Access Compliance Report

Public Rights-of-Way

Intersection ID: 3626	Main Street: LEXINGTON_APPROACH_DR	Cross Street: MALLARD_CREEK_RD	Location: E
ADA ID: D0B72CCA114C	Ramp Type: Perp	Initial Pass/Fail: Fail	Overall Compliance: No
Severity Score: 21.25			
Codes/Mitigation Info/Possible Solution		Field Measurements/Component Compliance

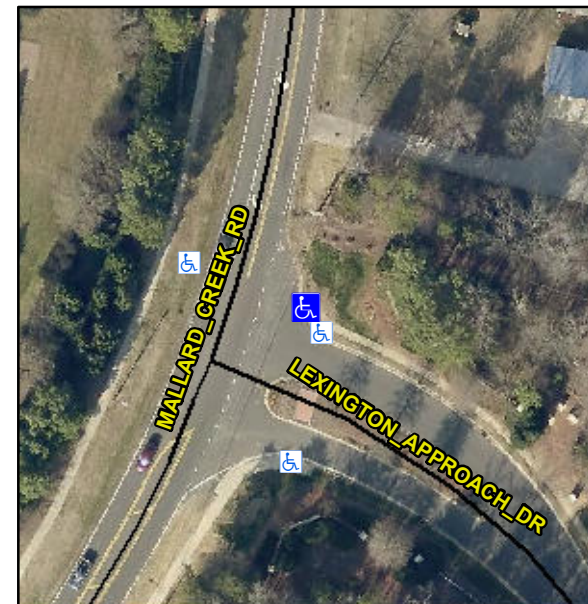
Remove & Replace Entire Ramp.

R304.5.1, R304.2.2

Compliance	Description	Data	Compliance	Description	Data
N/A	Ramp Length (in)	45.0	No	Ramp Slope (%)	10.6
No	Ramp Width (in)	36.0	Yes	Ramp XSlope (%)	1.3
N/A	Flare Type LT	N/A	N/A	Flare Type RT	N/A
N/A	Flare Slope LT (%)	N/A	N/A	Flare Slope RT (%)	N/A
N/A	Flare Traversable LT?	N/A	N/A	Flare Traversable RT?	N/A
N/A	Landing Length (in)	N/A	N/A	DWS Provided?	N/A
N/A	Landing Width (in)	N/A	N/A	DWS Contrast?	N/A
N/A	Landing Slope (%)	N/A	N/A	DWS Length (in)	N/A
N/A	Landing X Slope (%)	N/A	N/A	DWS Full Width?	N/A
N/A	Landing Curb? (Y/N)	N/A	N/A	DWS Offset (in)	N/A
N/A	Shared Landing?	N/A			
N/A	Gutter Ponding?	N/A	N/A	Gutter Slope (%)	N/A
N/A	Gutter Lip Ht (in)	N/A	N/A	Gutter X Slope (%)	N/A
N/A	Painted X Walk1?	No	N/A	Painted X Walk2?	N/A
	X Walk 1 Direction	To NW		X Walk 2 Direction	N/A
N/A	X Walk 1 Width (in)	N/A	N/A	X Walk 2 Width (in)	N/A
	X Walk 1 Slope (%)	7.5		X Walk 2 Slope (%)	N/A
	X Walk 1 X Slope (%)	2.8		X Walk 2 X Slope (%)	N/A
